UNITED STATES PATENT AND TRADEMARK OFFICE

APPLICATION NO.	FILING DATE	FIRST NAMED INVENTOR	ATTORNEY DOCKET NO.	CONFIRMATION NO.
10/660,827	09/12/2003	David B. South	89786	7862
24628	7590	12/28/2004		
WELSH & KATZ, LTD 120 S RIVERSIDE PLAZA 22ND FLOOR CHICAGO, IL 60606				
EXAMINER HORTON, YVONNE MICHELE				
ART UNIT		PAPER NUMBER		
3635

Office Action Summary	Application No. 10/660,827	Applicant(s) SOUTH, DAVID B.	
	Examiner Yvonne M. Horton	Art Unit 3635

DETAILED ACTION

EXAMINER'S EXHIBIT

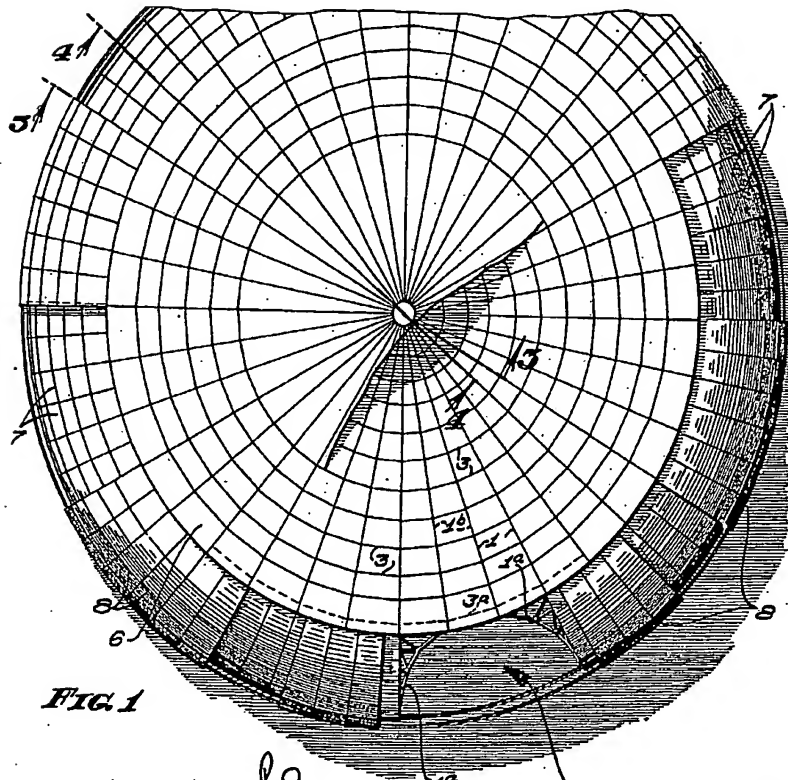
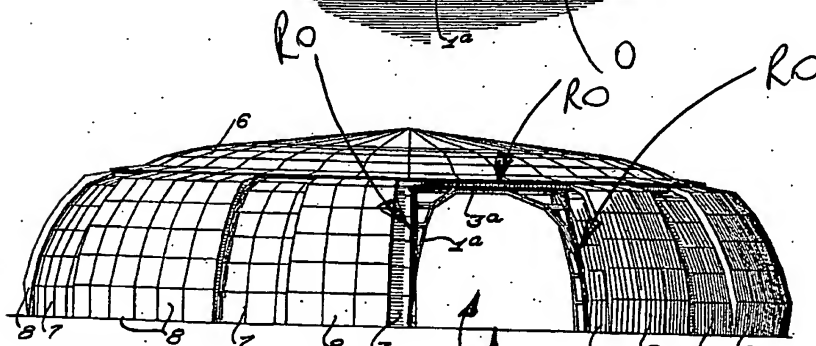
as to enable lateral movement such that the door (20a,20b) "compliments" the dome shape peripheral wall when in its first position and is disposed adjacent a wall of the dome shaped building when in its second position. SOUTH et al. discloses the basic claimed structure except for explicitly detailing that his door is domed shaped. Although SOUTH et al. does not detail the use of a dome shaped door, he does; however, disclose in column 3, line 31-33 that his door may take any form. Hence, SMITH teaches the use of doors (7,8) having a convex dome shape. It would have been obvious to one having ordinary skill in the art at the time the invention was made to form the door of SOUTH et al. domed shape, as taught by SMITH, in order to improve the aesthetic appearance of the building. Regarding claims 2 and 15, the building (22) includes a floor (F) which appears to the ground, see the marked attachment, SOUTH et al. does not disclose the use of the lower margin of the door being operated by wheels. SMITH; however, teaches the use of the door (7,8) having a lower margin operatively associated with roller wheel means (9b,10b) for engaging the floor surface (F) in rolling contact therewith and at least partially supporting the door (7,8). It would have been obvious to one having ordinary skill in the art at the time the invention was made to provide the structure of SOUTH et al. with the wheel means of SMITH in order to aid in opening the doors more quickly. In further regards to claims 14 and 21, the door (7,8) of SMITH is supported at an upper margin on a substantially horizontal guide track (17,18) for lateral movement between the first and second positions, the guide track (17,18) extending internally of said chamber (1) adjacent a wall of the building (22) so that the door (7,8) is disposed in closely spaced relation to said wall when in its

second position. Regarding claims 4,6,12 and 16, the interior chamber (IC) of SOUTH et al. is defined by an outwardly convexly curved peripheral wall having a substantially uniform transverse thickness. SOUTH et al.; however, does not disclose the use of a horizontal guide track. SMITH teaches that it is known in the art to include a substantially horizontal guide track (17,18) affixed to an inner surface of the wall adjacent the access opening (O), the door (7,8) having means (15,16) adjacent an upper marginal edge thereof for mutual cooperation with the track to enable lateral sliding movement of the door (7,8) between said first and second positions. Hence, it would have been obvious to one having ordinary skill in the art at the time the invention was made to provide the doorway and door frame of SOUTH et al. with the horizontal guide track of SMITH et al. in order to provide an easier way of maneuvering the concrete doors of SOUTH et al. In reference to claim 17, the door (7,8) of SMITH includes guide rollers (9b,10b) adjacent the upper margin thereof for operative association with said guide track (17,18) so as to facilitate lateral movement of the door (7,8) along the track (17,18). Regarding claims 7,13 and 18, the access opening of SOUTH et al. does not appear to be rectangular; however, the access opening (O) of SMITH is generally rectangular (RO) when considered in front elevation, and the door (7,8) having a similar generally rectangular peripheral configuration and having an outer three-dimensional convex contour substantially similar to the outer convex curvature of the dome shaped building (22), page 2, lines 53-54, adjacent the access opening (O). Hence, it would have been obvious to one having ordinary skill in the art to form the door opening and door of SOUTH et al. rectangular shaped, as taught by SMITH, in

order to ensure an exact fit between the door and the opening into which the door will be secured. In reference to claims 10 and 19, the door (7,8) of SMITH includes a plurality of upstanding horizontally spaced frame members (UF), the upstanding frame members (UF) having outer convex surface profiles similar to a convex profile of the dome building (22) adjacent the access opening (O), the upstanding frame members (UF) having a generally rigid sheet (SH) affixed to outer convex surfaces so as to form a rigid unified door (7,8) having an outer convex surface.
